Public Works Department  
Transportation Division

**California Street/Dwight Way Intersection Project  
Summary of Project Status, Selected Alternative, and Questions & Responses  
May 28, 2021**

SHEET 2 OF 2

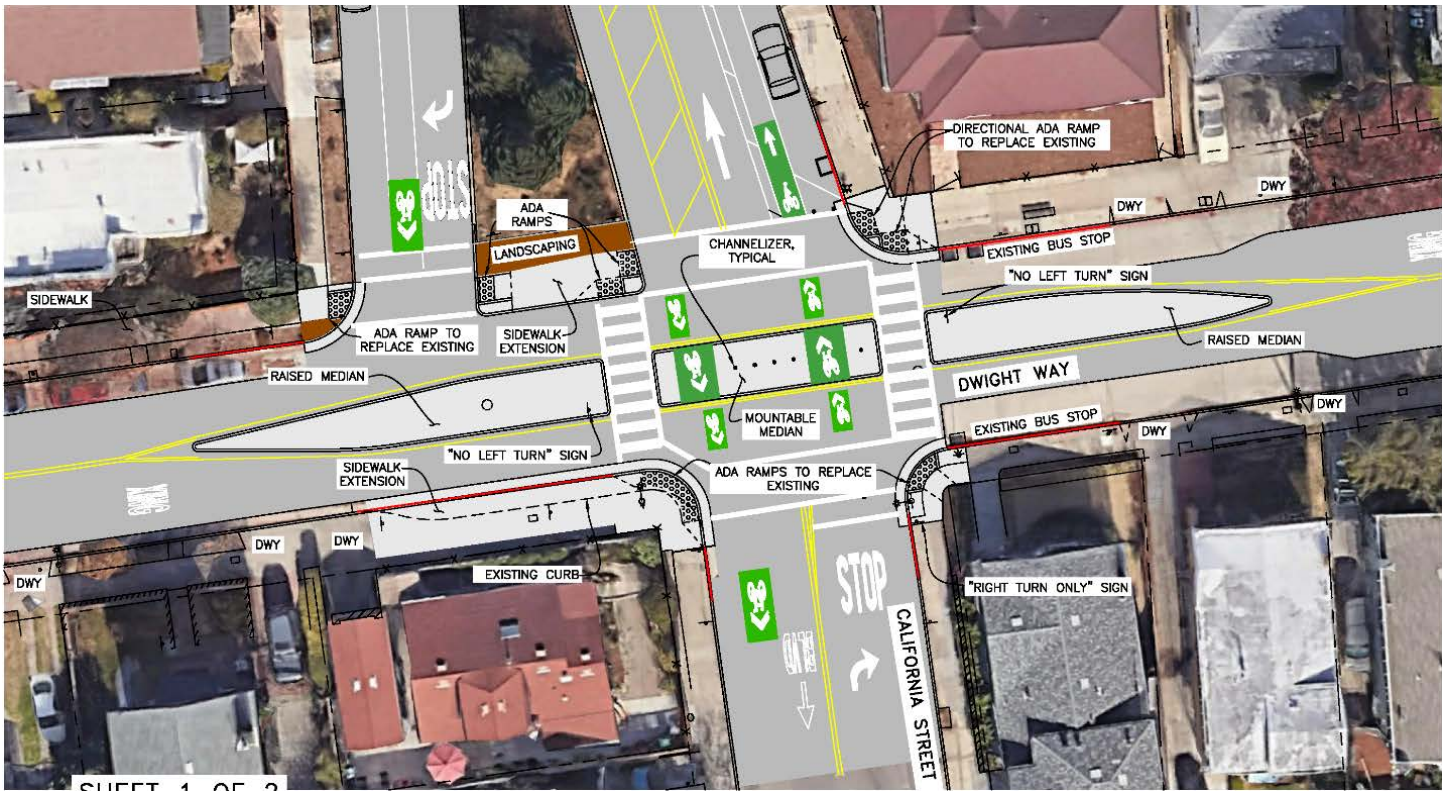
**Q: How is the proposed median refuge island, depicted as Alternative 1, intended to slow vehicles on Dwight?**

**Q: Regarding Alternative 1, why can't there be a median for the crosswalk and still allow left turns?**

**Q: Also regarding Alternative 1, would the median be wide enough to accommodate a bike towing a child in a trailer? This is a common configuration going through this intersection.**

R: As described in <https://nacto.org/publication/urban-street-design-guide/design-controls/design-speed/speed-reduction-mechanisms/>, medians create a pinchpoint for traffic in the center of the roadway and can reduce pedestrian crossing distances. The median would narrow the effective width of traffic lanes on Dwight at the intersection, as the existing lanes on Dwight at the Dwight/California intersection are wider than needed. In general, extra-wide streets make many drivers comfortable driving faster, whereas narrower traffic lanes typically lead to reduced speeding.

R: A break in the median to allow left turns is technically possible but would no longer provide a separated refuge for people on bikes and would not reduce traffic volumes on the Bike Boulevard (California Street), which is called for in the Bicycle Plan.

R: The median would have a minimum width of 10 feet, which should be sufficient to accommodate a bike towing a trailer. The actual width of the median would be determined based on a balance of vehicle lane width and safety buffer for bikes towing a trailer in the median.

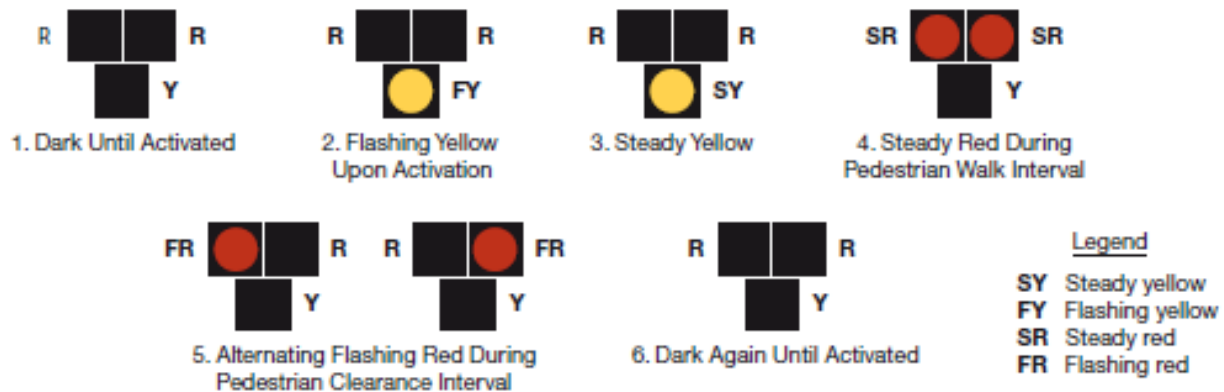
**Q: Describe the City's experience with Pedestrian Hybrid Beacons and how they operate.**

R: The City's first Pedestrian Hybrid Beacon (PHB, also known as HAWK [High Intensity Activated CrossWalk] beacons) was installed at the Ashby/Hillegass intersection in approximately 2018 to address pedestrian and bicyclist safety concerns with crossing Ashby Avenue, a Major Street as identified in the City's General Plan. PHBs are primarily intended for use as a traffic control device to stop vehicles to allow protected pedestrian crossings. PHBs differ from traditional traffic signals in that traffic on the cross street (Ashby) only stops when the PHB is activated and vehicles on the crossing street (Hillegass) do not have a signal to facilitate crossing; these vehicles are controlled on Hillegass with stop signs.

As described in [https://safety.fhwa.dot.gov/ped\\_bike/tools\\_solve/fhwasa14014/](https://safety.fhwa.dot.gov/ped_bike/tools_solve/fhwasa14014/) PHBs operate as follows: The design of the PHB consists of two horizontally-arranged red lenses above a single yellow lens. As shown below, the signal face for drivers remains unlit or "dark" until the pedestrian activates the system. While the signal is dark, the pedestrian display shows a Don't Walk indication. To activate the PHB pedestrians push an accessible button located on a pole or post at the roadside. The actuated beacon then begins to flash yellow to warn motorists that the beacon has been activated. This brief flashing yellow interval is followed by a steady yellow interval, then by a steady red signal indicating motorists need to come to a complete stop and wait at the stop line. While motorists are seeing the steady red indication, the Walk sign is lit for pedestrians, allowing them to cross the roadway. After the pedestrian WALK phase ends, the pedestrian signal indication changes to a flashing DON'T WALK to notify pedestrians not to begin crossing. During the flashing Don't Walk phase, the PHB displays alternating flashing red lights to drivers. The flashing red indicates to drivers that they are to stop and yield to pedestrians in the crosswalk, and can proceed once pedestrians are clear.
